IN RE APPLICATION OF: U.S. Patent No. 6,917,232

FOR: METHOD AND APPARATUS FOR GENERATING A QUADRATURE CLOCK

37 CFR 1.322 & 37 CFR 1.323 REQUEST FOR CERTIFICATE OF CORRECTION

On sheet 3 of 8, Fig. 3, delete

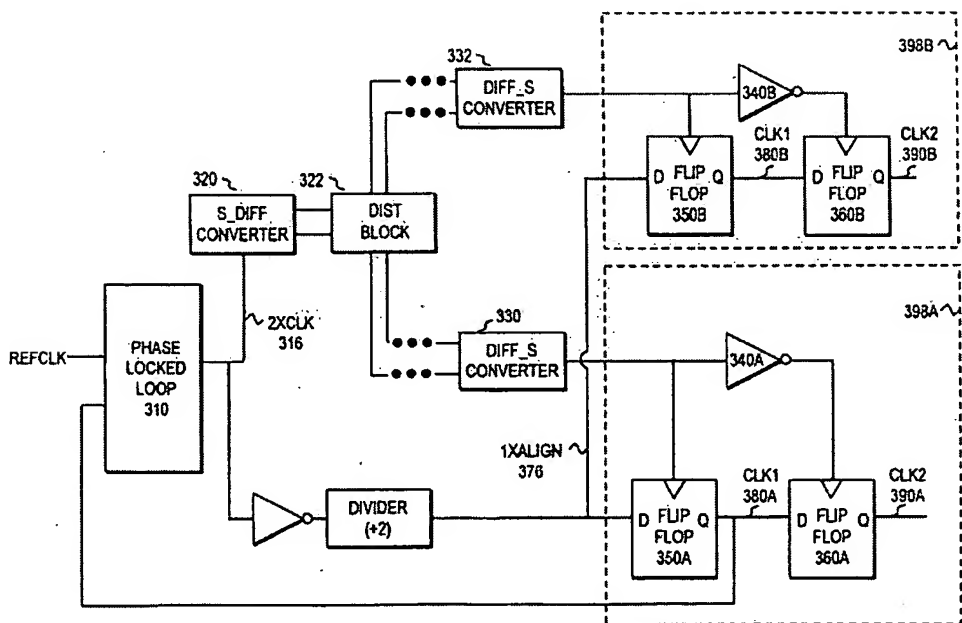
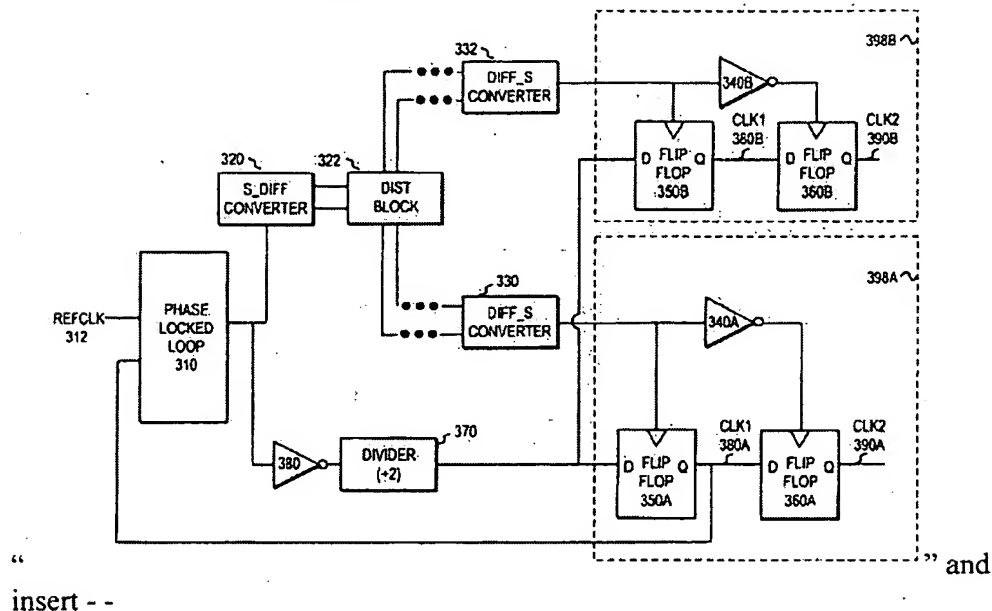
--, therefor.

(Amendment to drawings filed on Apr. 04, 2005, sheet 3/8, Fig. 3)
